Report to the Future Melbourne (Planning) Committee

Planning Permit Application: TP-2015-81/A 1-11 Epsom Road, Kensington

Planning Permit Application Delegate Report

APPLICATION NO:	TP-2015-81/A
APPLICANT:	St Marys Coptic Orthodox c/- SJB Planning Pty Ltd
OWNER:	Coptic Orthodox Church (Victoria) Property Trust
ARCHITECT	Studio Bright
ADDRESS:	1-11 Epsom Road, Kensington
PROPOSAL:	Amending the description of what the permit allows to include "Use of land for Child Care Centre", a nd amending the plans endorsed under the permit to make consequential changes to the development associated with the introduction of this land use.
COST OF WORKS:	N/A
DATE OF APPLICATION:	5 June 2019
DATE OF REPORT:	19 November 2019
CITY OF MELBOURNE STATUS:	Melbourne City Council is the Responsible Authority for Application TP-2015-81/A
RESPONSIBLE OFFICER:	Colin Charman, Acting Principal Urban Planner

17-002	St Marys Church 5-11 Epsom Rd Kensington	
TP03.3	4/6/19 PROPOSED BUILDING ELEVATIONS

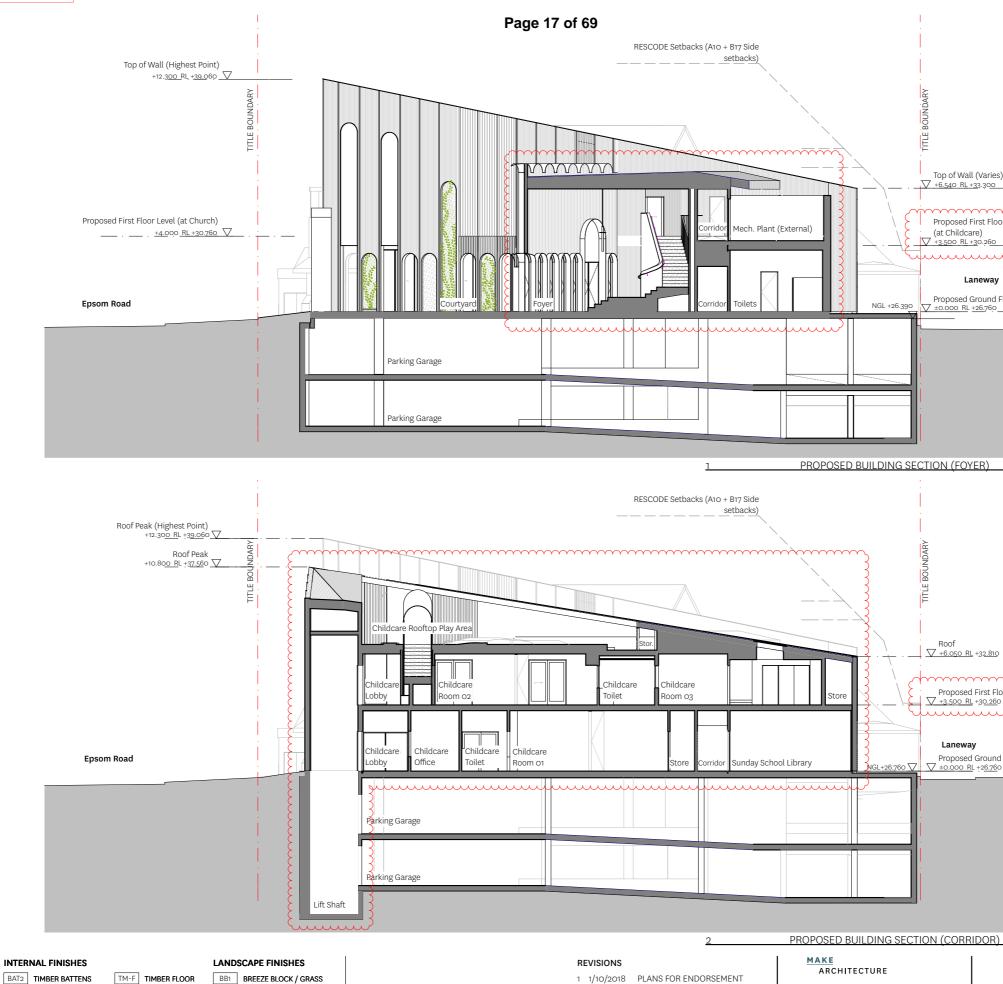
The fence form proposed is an organic arrangement which complements the proposed building. Although the drawing depicts a semi-transparent form, the annotation PF does not describe permeability in the materials schedule. A tall, solid fence would impact on the streetscape in Epsom Road and diminish the initial concept for open spaces shared with the community. Further clarification of the visual permeability of the fence would assist in assessment of the impact in Epsom Road.

The applicant provided further detail regarding these elements on 4 October 2019 to assist Council's assessment (an excerpt from the further detail regarding the appearance of the front fence is provided in Figure 6 of this report).

Subject to a condition being included on any amended permit being granted requiring this design detail to be further clarified on amended plans prior to endorsement, it is considered that the proposed fence will present to the street as a simplified and modern structure, which will not interfere with any established heritage streetscape character along Epsom Road (representing a 'Level 3' graded streetscape).

Figure 4: Excerpt from Drawing No. TP02.1 Proposed Ground Floor Plan, with Child Care Centre use highlighted (yellow: indoor, green: outdoor)

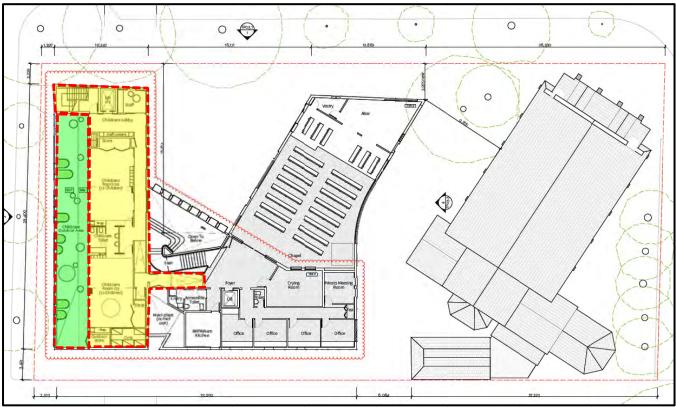
- The child care drop-off and pick-up arrangements within the basement are acceptable, however it was noted that any amended permit being granted should include a condition requiring the car parking spaces dedicated to the child care centre to be formally annotated on the plans (and that appropriate signage should be provided).

- h) The location and type of wayfinding signage to ensure visitors to the Child Care Centre are able to readily locate car parking areas dedicated to this use.
- i) The direction of vehicle ingress (which must be via The Ridgeway) and egress (which must be to Kensington Road).
- j) Corrected column locations on the basement plans, generally in accordance with Drawing No. TP02.5 & TP02.6 prepared by Studio Bright received 26 September 2019.
- k) A visually permeable front fence design incorporating fine vertical elements with openings to maintain a high degree of visual transparency (at least 50% open), generally in accordance with Drawing No. TP06 prepared by Studio Bright received 4 October 2019.

Figure 7: Excerpt from Drawing No.TP03.1 Streetscape Elevations (Proposed)

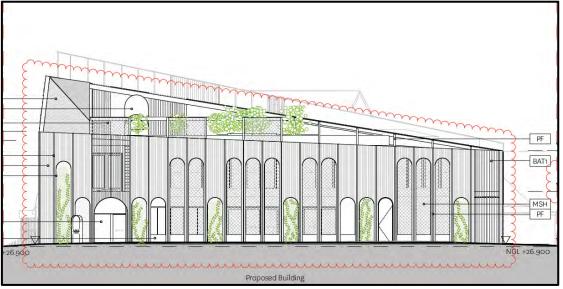
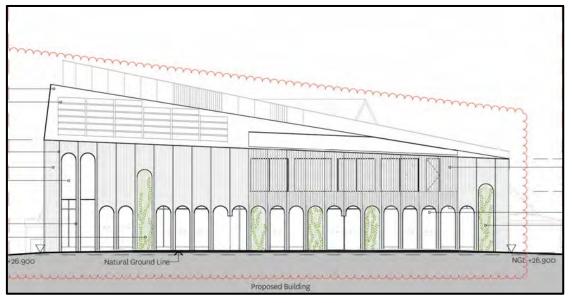
It appears that the roof profile would be altered in the region of the proposed lift and toilet at the Roof Terrace level. The South west elevation appears to indicate that the balustrade for the Roof Terrace play space is contained within the sloping roof volume. If this a correct appraisal, the only changes which would impact on the potential for increased bulk are the lift and toilet and any associated shading which might be required over the play space. The documents indicate that there would be no roof over the Roof Terrace play space. Assessment of the impact on The Ridgeway would be assisted by a section parallel with Epsom Road, taken through the west wing roughly half way along the length of the proposed Roof Terrace play space.

The design response of the roof-top terrace to the western wing of the approved development under Application TP-2015-81/A, therefore ensures that the replacement building continues to achieve a satisfactory heritage outcome for the site.

Figure 9: Excerpt from Drawing no. TP03.7 Overlooking Diagrams

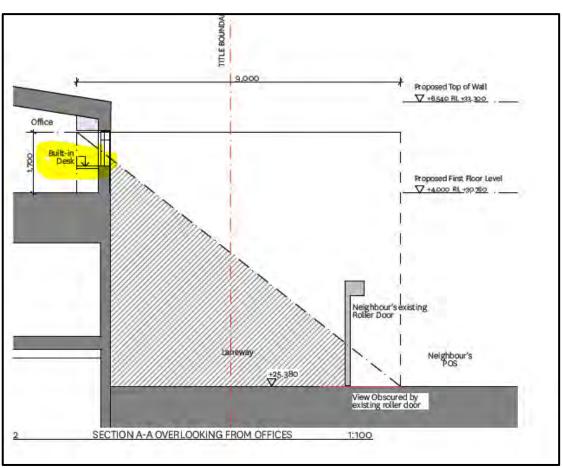
Section diagrams submitted with the application appear to show built-in desks being relied upon to limit views in accordance with the requirements of Standard B22 to *Clause 55.04-6 Overlooking Objective*.

Reliance on built-in desks to limit views into neighbouring rear secluded private open space is not identified as an accepted screening method under Standard B22 to *Clause 55.04-6*.

Subject to a condition being included on any amended permit being granted requiring fixed horizontal louvres to be installed to the south-west facing windows of the first floor of the central wing located within a horizontal distance of 9 metres (measured within a 45 degree angle of the window plane) to the rear secluded private open space of 1 The Ridgeway, designed in accordance with Standard B22, it is considered that views will be reasonably limited.

- f) Fixed horizontal louvres to the south-west facing windows of the first floor of the central wing located within a horizontal distance of 9 metres (measured within a 45 degree angle of the window plane) to the rear secluded private open space of 1 The Ridgeway, Kensington. These horizontal louvres are to be configured in a manner that limits views in accordance with the requirements of Standard B22 (Clause 55.04-6 Overlooking Objective) of the Melbourne Planning Scheme.
